Project Name: UNIVERSITY OF CALIFORNIA, MERCED
COB ROOMS 110 & 114 RENOVATIONS
Project No.: 907015

ADDENDUM NO. 3
to the
CONTRACT DOCUMENTS
August 22, 2012

A. RE-ISSUE THE FOLLOWING DRAWING SHEETS

Drawing Title:
NEW INTERIOR ELEVATIONS (BID ALTERNATE)

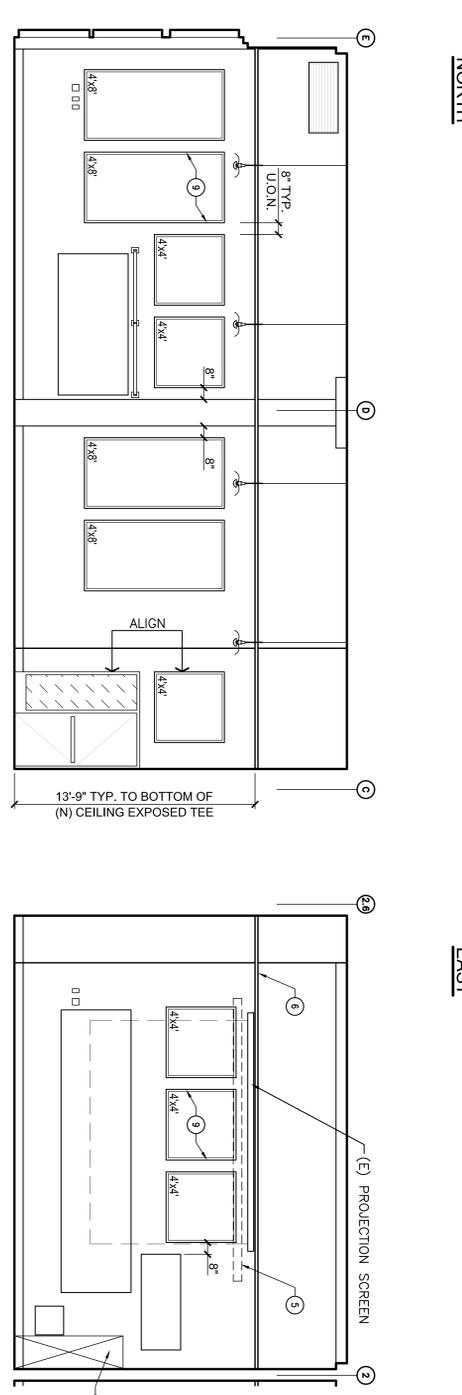
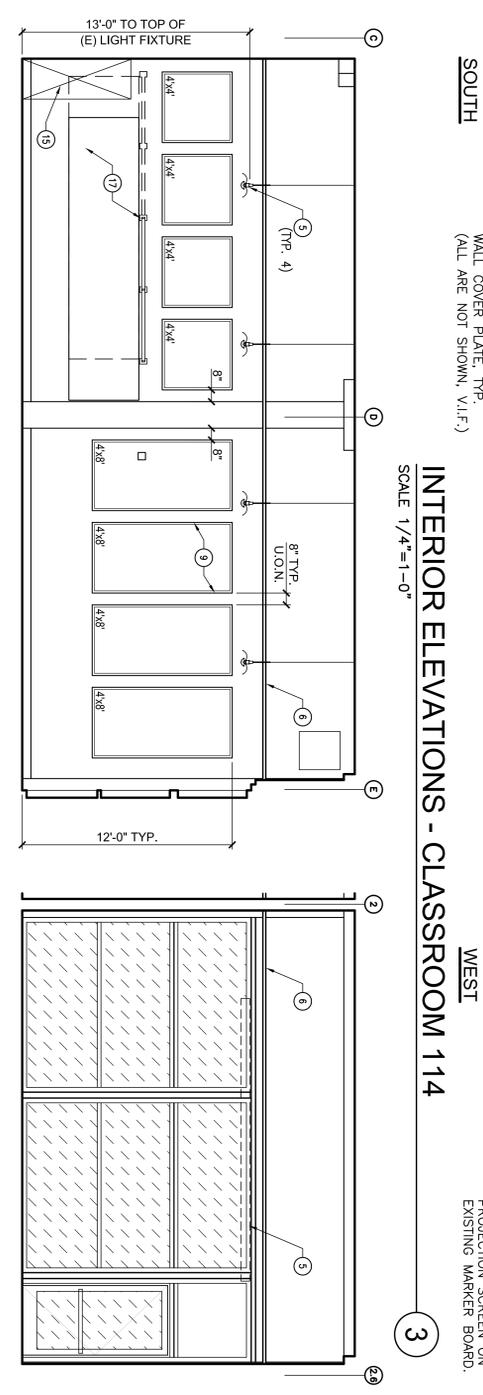
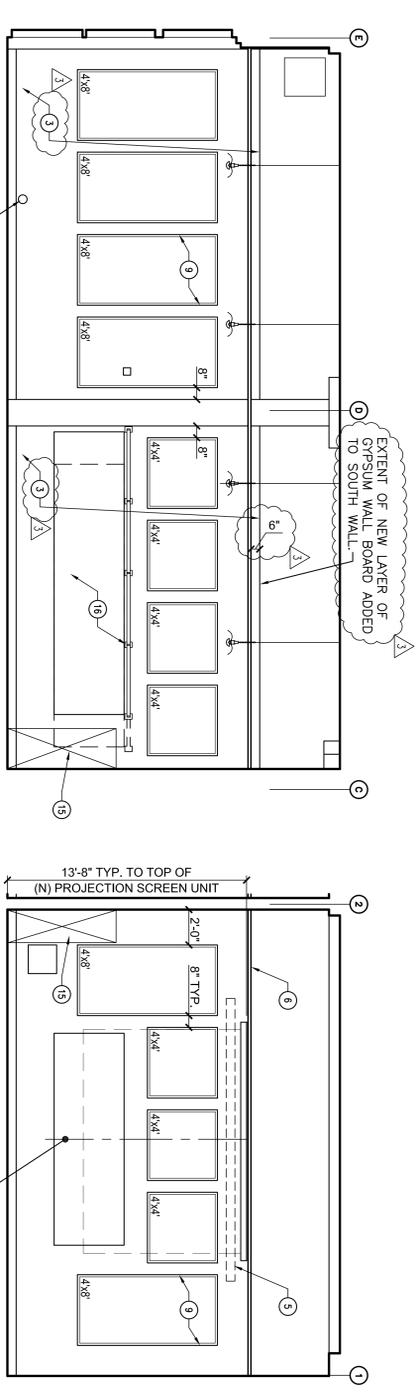
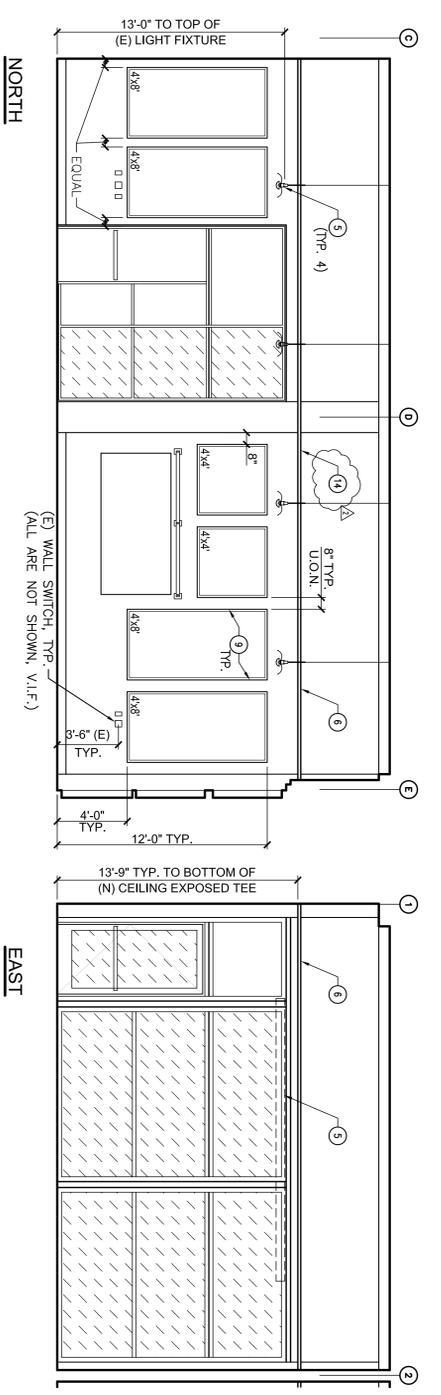
BID ALTERNATE NOTE:
PROVIDE ACOUSTICAL WALL PANEL WORK ON THIS SHEET A-272a INSTEAD OF ACOUSTICAL WALL PANEL WORK SHOWN ON SHEET A-272. ALL OTHER WORK ARE THE SAME ON TWO SHEETS.
